SmartAmp 2.0: 2-Channel Biopotential Amplifier by Rafael Betancourt-Zamora

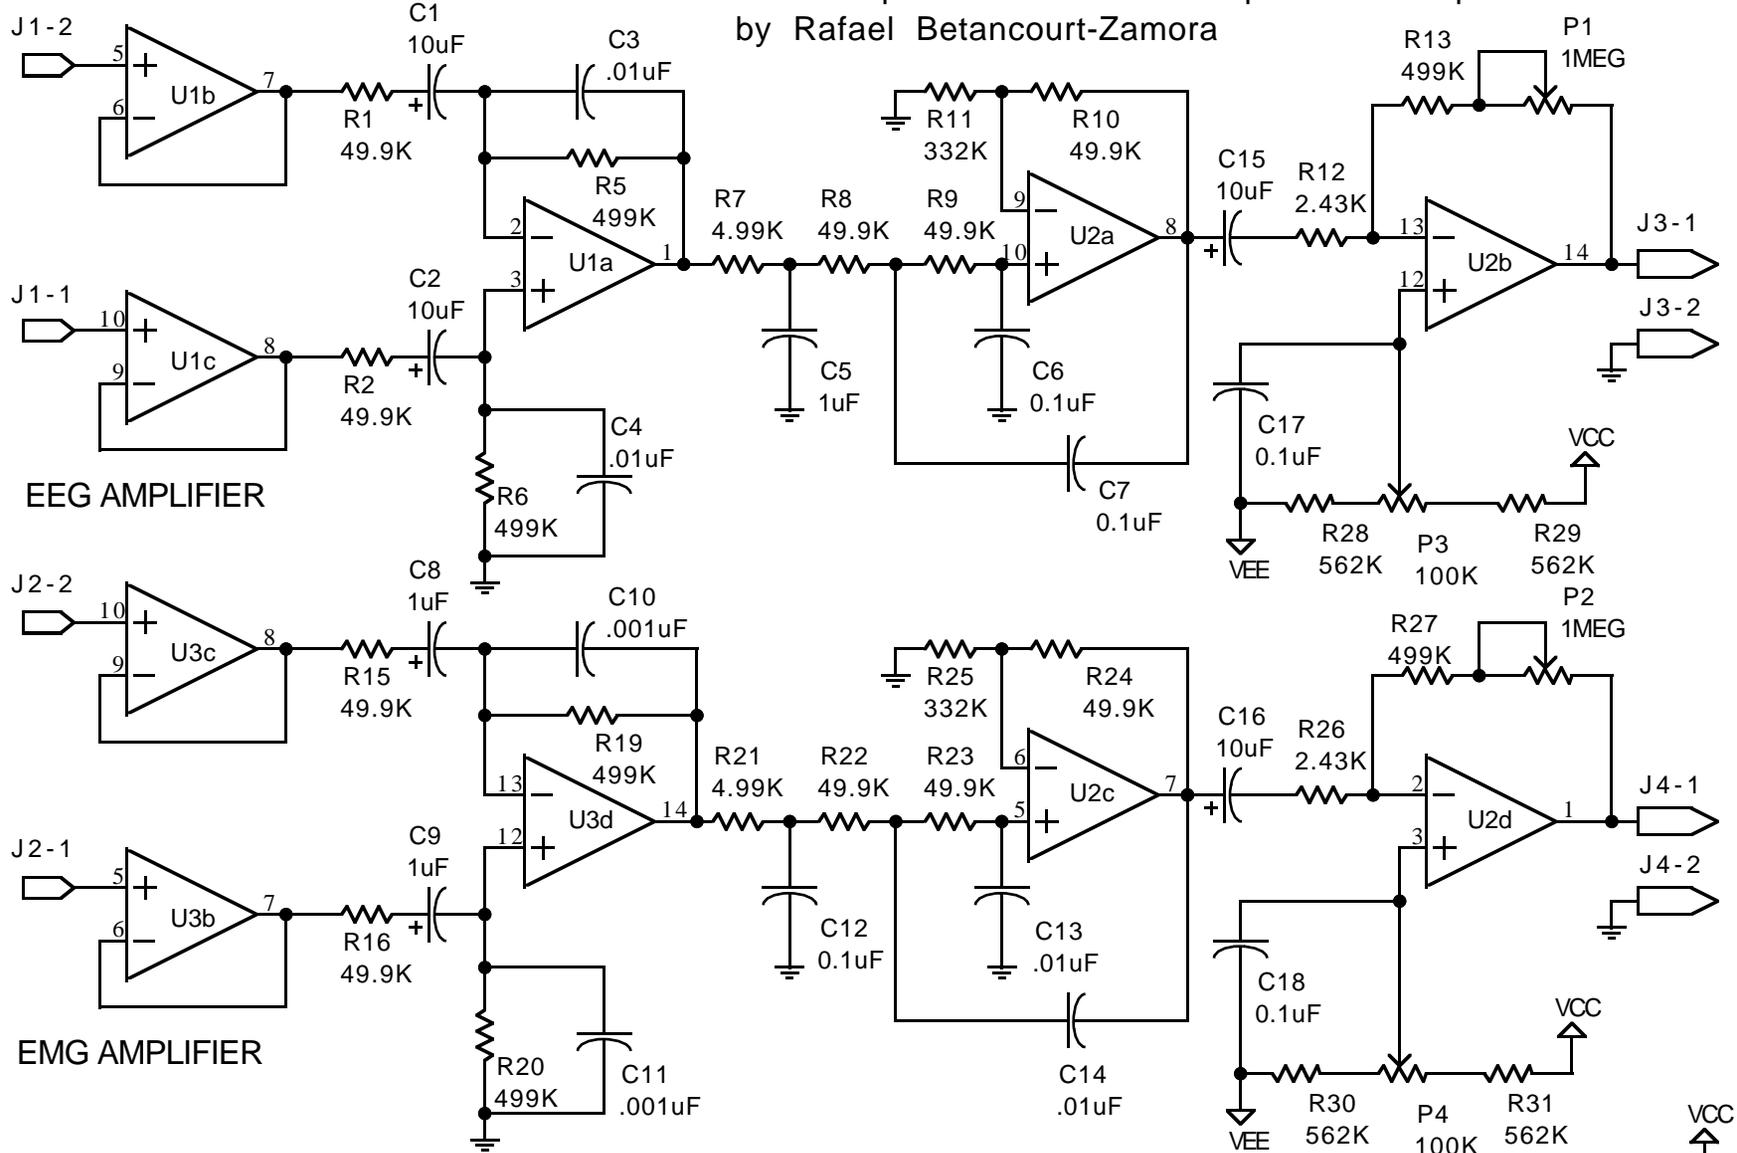
10-22-95 added C15, C16, C17, C18, CB1, CB2, CB3
 10-17-95 added offset adjustment (R28, R29, R30, R31)
 08-03-95 removed driven shield (U1c, U3c, R3, R4, R14, R15, R17, R18)
 09-09-94 created
